Statesville Office (704) 878-5305 Mooresville Office (704) 660-3625 PERMIT # 210749

IMPROVEMENT PERMIT / AUTHORIZATION TO CONSTRUCT / OPERATION PERMIT / EXISTING SYSTEM

Attached is a proposed design for a PPBPS Septic System with gravity distribution for a 4 bedroom single family residence at 297 Tennessee Circle, Mooresville, NC 28117, Iredell County, North Carolina.

June 22, 2015
Project No.01-3021
Design By: Rollans Soil & Environmental Services, PA

INITIAL SITE SKETCH

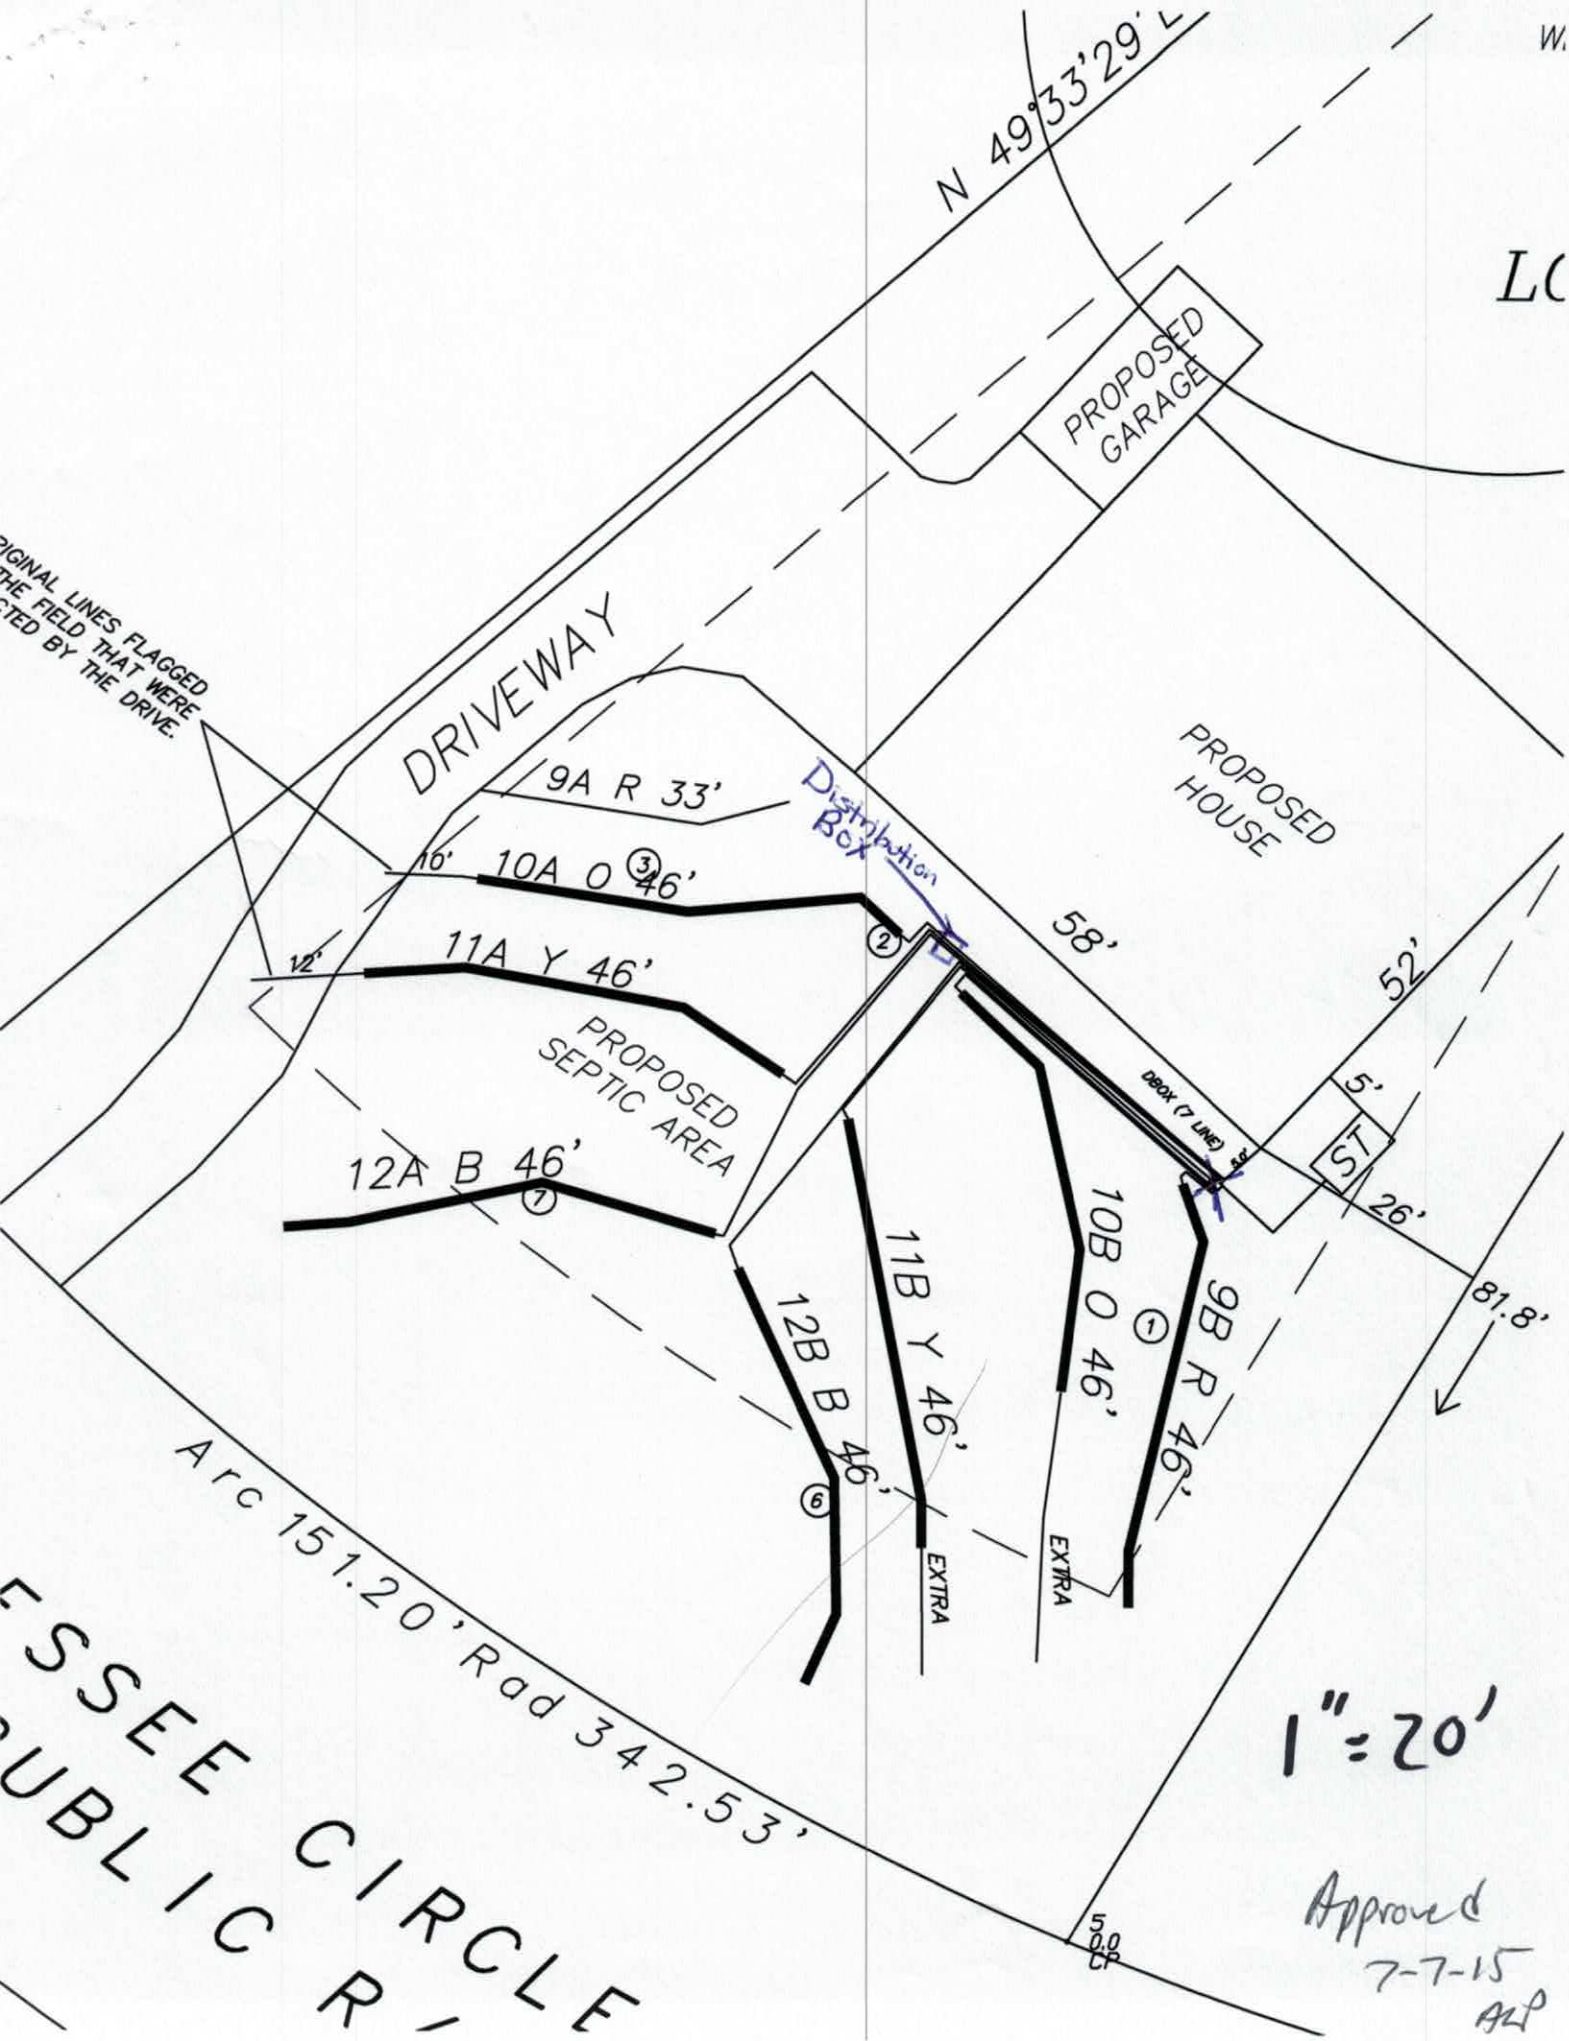
Comments / Conditions: * 30" Trench bottom per design
- If gravity can not be maintained a pump will be required *

10/23/15 Reviewed Floor plans, in compliance with Septic plan
Distribution box installed 12ft from Corner of house, 11ft from porch steps & 9½ ft straight out from house.

Installed as Drawn

FIRST FLOOR PLAN 1/4" = 1'-0"

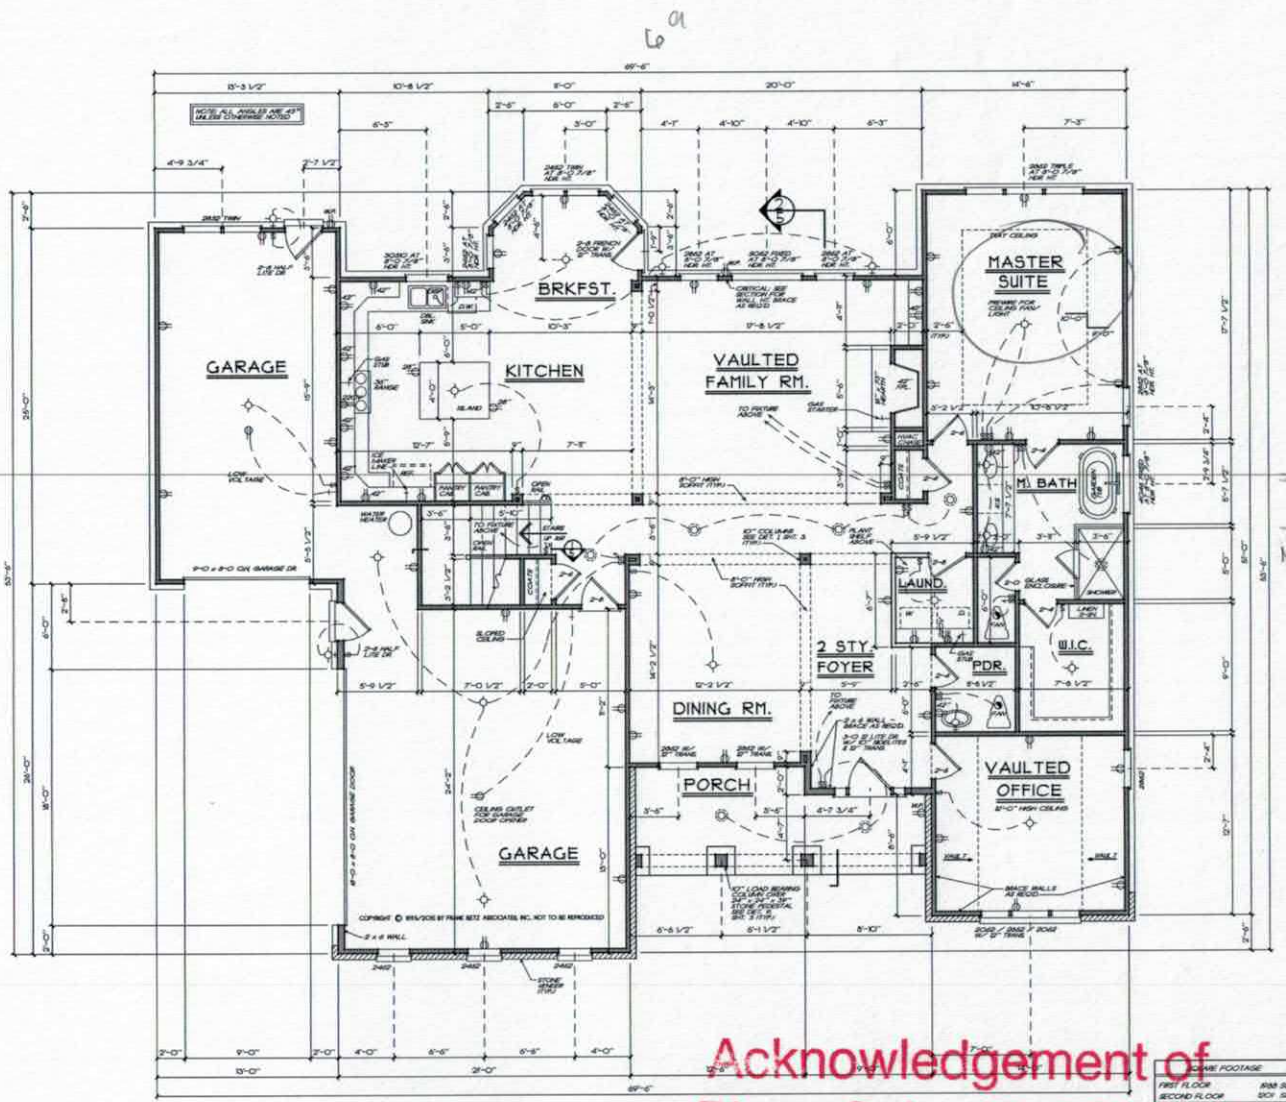
Acknowledgement of Plans Submittal ONLY!
